**DOCUMENTED CHANGE REQUEST**

Proposal Number:	QXQ1K1017B_V1.5
Project Number:	P4CZ009933
Project Name:	Personal Safety Interlock System
Project Manager:	Stephan Richter

DCR#: 01	Date: 24.10.2018
Subject: Additional E1 control panels and trapped key System/ Connection to L1 building fire alarm system	Initiated By: Eli Beam

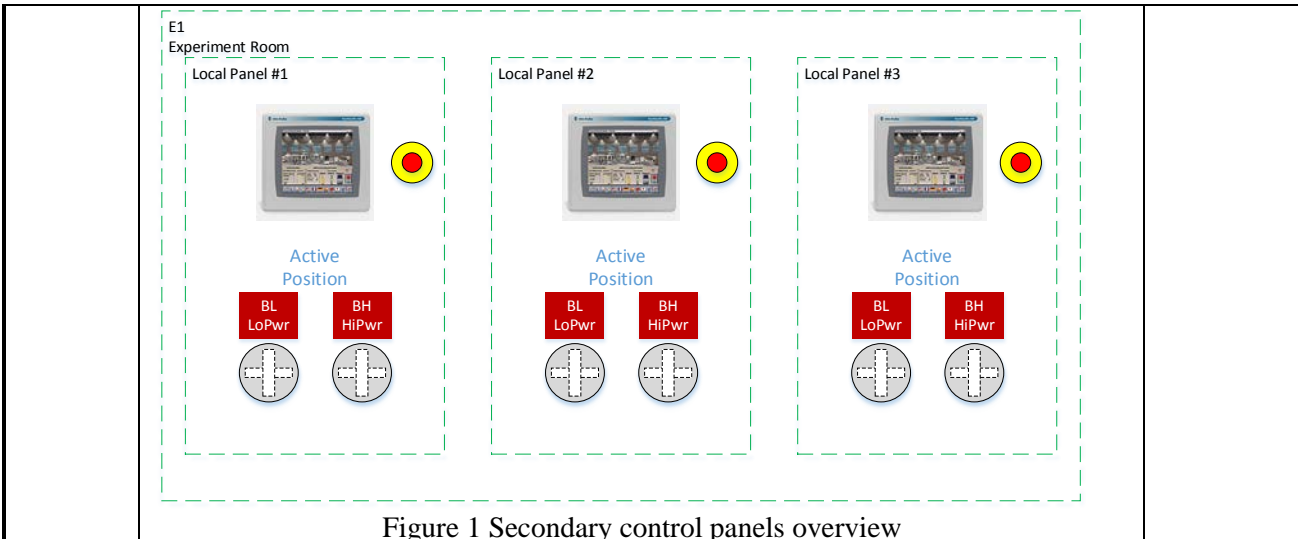
- The secondary control panel(s) shall be as compact as possible and consist of a wall-mounted cabinet of minimal depth and shall be provided with installation and all necessary cable management and routing;

- The secondary control panel(s) shall include the same PavelView HMI display panel as in the control room (as in P4CZ009933-DWG-1304);
- The secondary control panel(s) shall be equipped with a Beam off Button (BoB) in accordance with existing requirements;

- The secondary control panel(s) shall be equipped with a pair of Trapped Key sockets for Alignment and Hi-Power Mode activation.
- From a secondary control panel, it shall be possible to:

- View the same status information as displayed in the primary panel (for example Figure 40 in P4CZ009933-FDS-en(V1.0B));
  - Enact mode changes from master secondary panel (Provided all relevant enabling conditions (including key permissives) have been given) **with the exception of enacting mode changes M0 – Closed and M3 – Search**, which shall be possible only from the primary display panel;

- Request a transition to a less hazardous state from all secondary panels (e.g., M4->M2 or M2->M1) without entering any pin number or user credentials with a minimum number of user operations (i.e., a single button press);

- Perform all other operations in an identical way to the main control panel, such as resetting interlock trips and viewing alarms;
